**RE: MOUNT PLEASANT OPTIMISATION PROJECT – GREENHOUSE GAS EMISSIONS**

This letter provides MACH Energy's (MACH's) response to the matters raised by the New South Wales (NSW) Department of Planning, Industry and Environment (DPIE) (now Department of Planning and Environment [DPE]) Climate and Atmospheric Science (CAS) regarding the estimated greenhouse gas emissions of the Mount Pleasant Optimisation Project (the Project) (letter dated 10 December 2021).

**RE: Mount Pleasant Optimisation Project Greenhouse Gas Assessment – Additional Information**

**RE: Mount Pleasant Optimisation Project Greenhouse Gas Assessment – Revised Fugitive Emission Estimates**

**Chart 1**  
**Comparison of Relevant Fugitive Emission Factors**

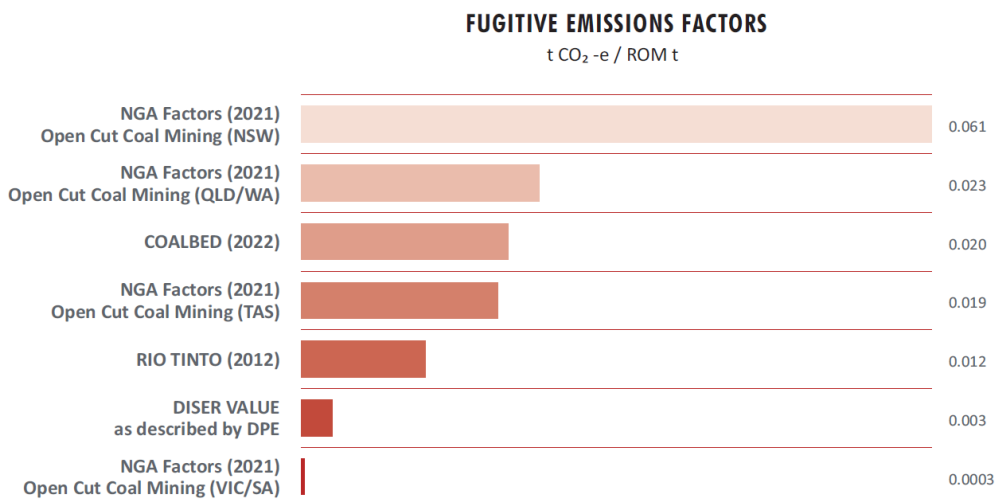
*The proponent's fugitive emissions intensity for the Project appears to be relatively high for an open-cut mine. It would be helpful if the proponent could discuss the reasons for this in terms of the nature of the seams to be mined, the coal seam gas content levels in m<sup>3</sup>/t and %methane content of the gas to be encountered.*

MACH notes that the National Greenhouse Accounts (NGA) default factors for open cut coal mines in Australia range from 0.0003 t CO<sub>2</sub>-e/ROM t for Victoria and South Australia, to 0.061 t CO<sub>2</sub>-e/ROM t for open cut mines in NSW<sup>1</sup> (Chart 1).

It is unclear where the 0.003 t CO<sub>2</sub>-e /ROM t quoted from DISER is derived, or if it could be a misquote of the Victorian and South Australian default value of 0.0003 t CO<sub>2</sub>-e/ROM t for open cut coal mines in those states. Irrespective, it is clear that the site-specific value of 0.012 t CO<sub>2</sub>-e/ROM t developed by the former owner of the Mount Pleasant Operation (Rio Tinto, 2012) and adopted in the Project EIS is considerably lower than the NSW default for open cut mines under the NGA Factors (Chart 1).

The revised average fugitive emission factor using the more conservative methodology and higher adopted GWP of methane still remains low relative to the default NGA factor for NSW open cut mines (i.e. is approximately 33% of the NGA default fugitive factor) (Chart 1). Therefore, MACH considers the Mount Pleasant Operation incorporating the Project would have a low rate of fugitive greenhouse gas emissions, relative to other NSW open cut coal mines as indicated by the default NGA factor. Furthermore, the revised average fugitive emission factor is comparable to the default NGA default fugitive factors in other States in Australia, with the exception of Victoria and South Australia.

**Figure 3: Schematic of Surface to Inseam Drilling**

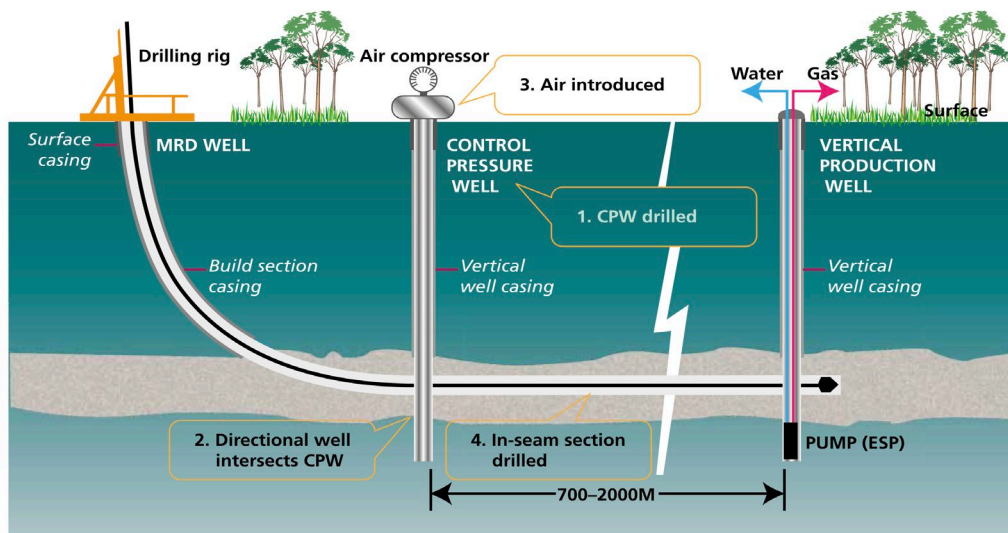
*The proponent should discuss if pre-drainage of methane from the coal seams is feasible or not, providing detailed reasoning to support the judgement. If it is feasible, the proponent should consider beneficial uses of the methane besides e.g. flaring.*

- Surface to Inseam Drilling – involves drilling a borehole through a medium radius arc which intersects the target coal seam at a tangent, then continuing the borehole laterally (or horizontally) within the seam, intersecting a pre-drilled vertical borehole (Figure 3).

Given the Project is a multi-seam open cut coal mine, any pre-drainage operation would likely rely on the development of vertical wells to connect multiple coal seams to any gas extraction point. This generally precludes surface-to-seam drilling as the number of target coal seams is far too high to employ this methodology economically in advance of mining.

Figure 1: Summary of quantities of materials consumed for the Project

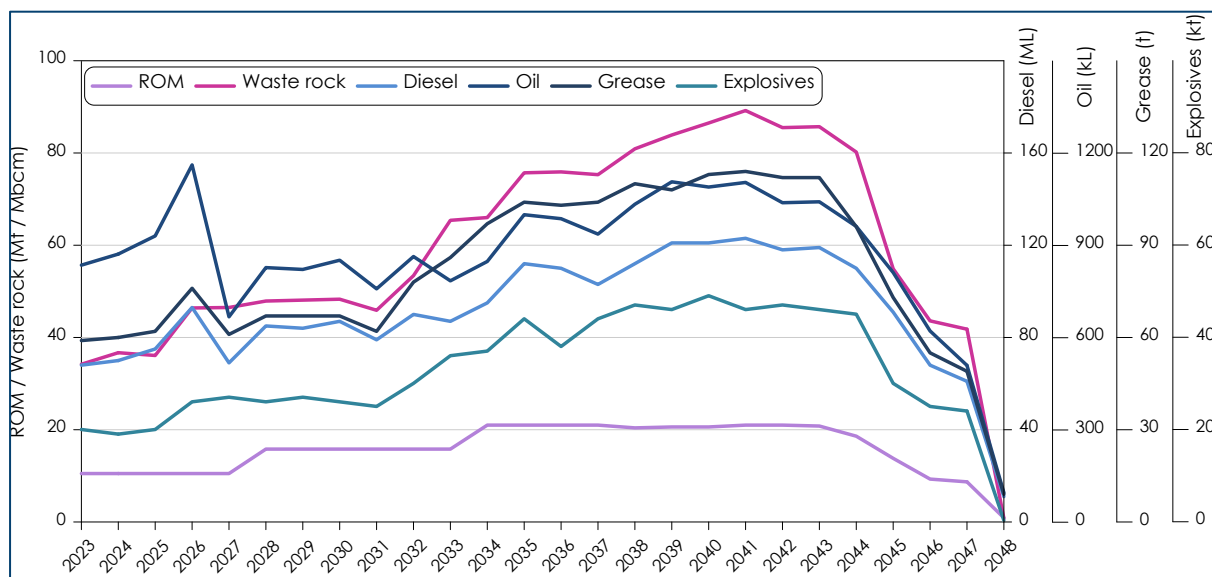
*1) The proponent should provide assumptions for quantities of all materials consumed for the Project in the construction and operations phase. If these are significant, use embodied emission factors to calculate emissions from each material.*

**Figure 1** presents a summary of estimated quantities of materials (excluding electricity) as presented in Table 2-1 of the GHG report. The amount of waste rock handled in each year has also been included for reference. We see from the figure that the amount of ROM extracted undergoes step changes from 10.5 million tonnes (Mt) in the first five years to 15.75Mt in the following six years before peaking at 21Mt for the next four years. The step changes in ROM extraction are not followed by the other materials due to the factors which influence the estimated requirements described above.

**Figure 1** also demonstrates that the estimated quantities of materials account for the periods of construction that occur throughout the life of the Project. For example, there is an increase in estimated diesel, oil and

grease usage in 2026 that corresponds with the anticipated Stage 2a expansion of the Mine Infrastructure Area and Coal Handling and Preparation Plant, as well as Raise 2 of the Fines Emplacement Area.

Given the various factors influencing the estimated materials quantities used in the GHG report, including the effects of construction activities, simplifying the material usage estimates to base assumptions is not somewhat simplistic. Notwithstanding, in consideration of the DPIE's request, the following usage rates have been calculated on an annual average basis over the life of the Project inclusive of construction activities:

- ✦ diesel: ~6.2 megalitres per million tonnes of ROM coal (ML/Mt ROM);
- ✦ oil: ~60.3 kilolitres per million tonnes of ROM coal (kL/Mt ROM);
- ✦ grease: ~5.4 tonnes of grease per million tonnes of ROM coal (t/Mt ROM); and
- ✦ explosives: ~2.0 kilotonnes per million tonnes of ROM coal (kt/Mt ROM).

Figure 2: Summary of quantity of electricity for the Project

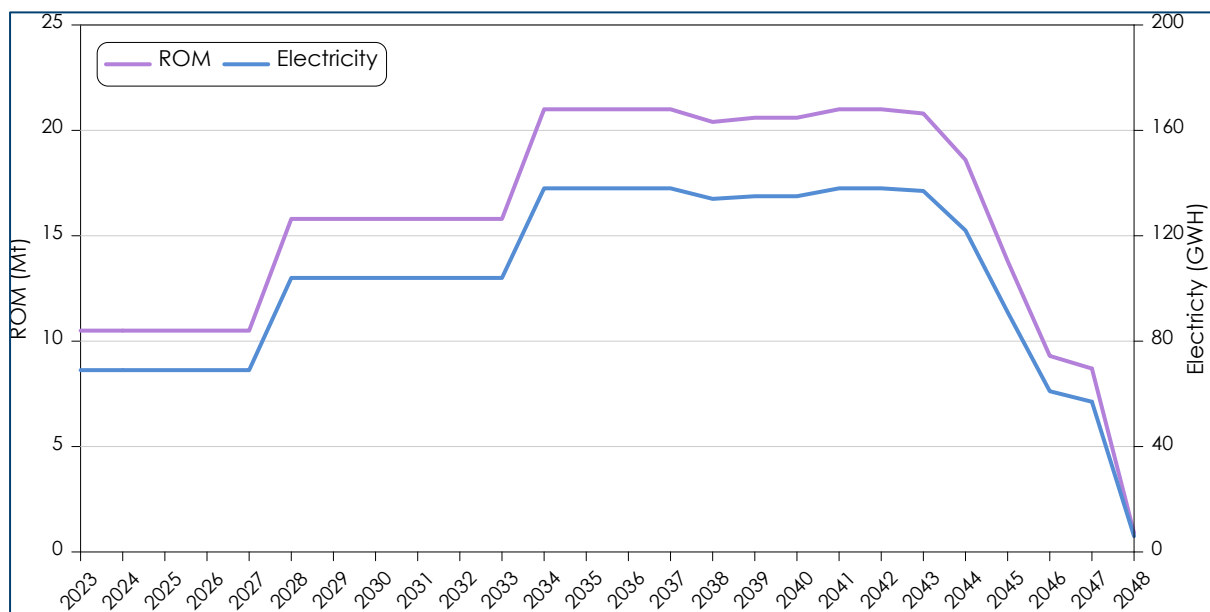
*6) Assumptions for electricity consumption should be given.*

As noted, the quantities of all materials consumed for the Project were estimated through the mine planning process and in consideration of usage at the existing Mount Pleasant Operation. Electricity usage was estimated using a similar process. **Figure 2** presents a graphical summary of the electricity consumed for the Project with the amount of ROM extracted. Based on these values, a factor of approximately 6.6 gigawatt hours GWh per million tonnes of ROM coal extracted can be determined (GWh/Mt ROM).

Figure 3: Summary of quantities of coal for the Project

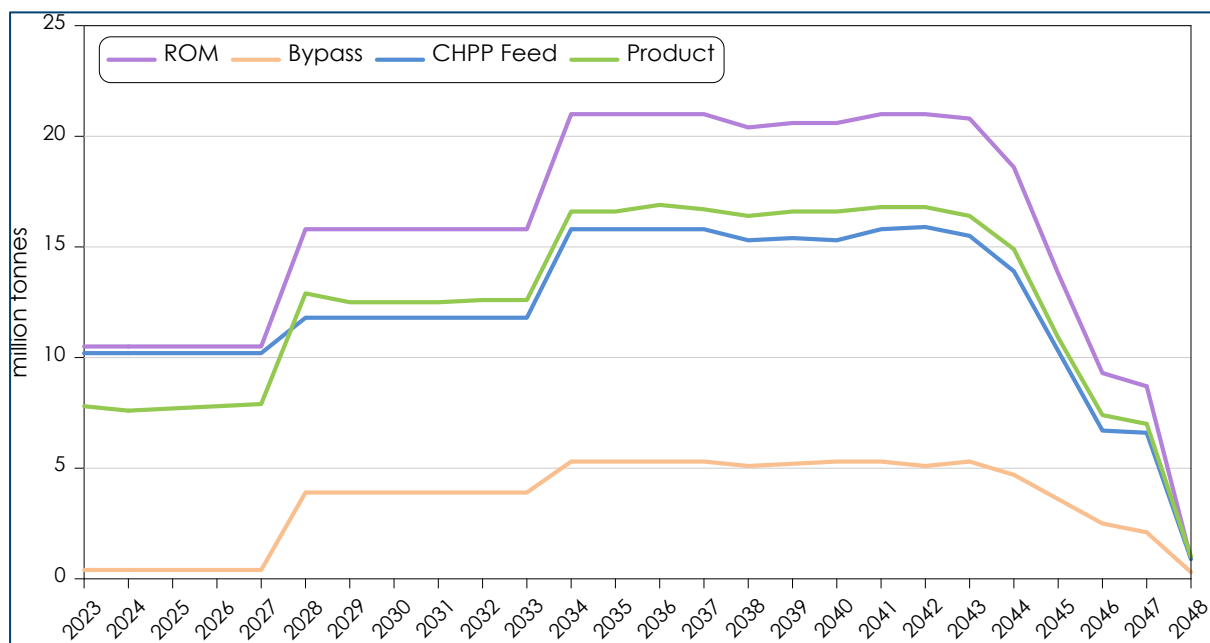
7) The proponent should provide the conversion factor for ROM to product coal volumes or a column of annual product coal figures so that the Scope 3 calculations can be verified.

The values for ROM, bypass, CHPP feed and product coal for the Project are summarised in **Table 1** and **Figure 3**. The amount of product each year is calculated as the bypass plus the processed coal from the CHPP. The percentage yield from ROM processed to product coal ranges from approximately 72% to 82% depending on the year (excluding 2048).
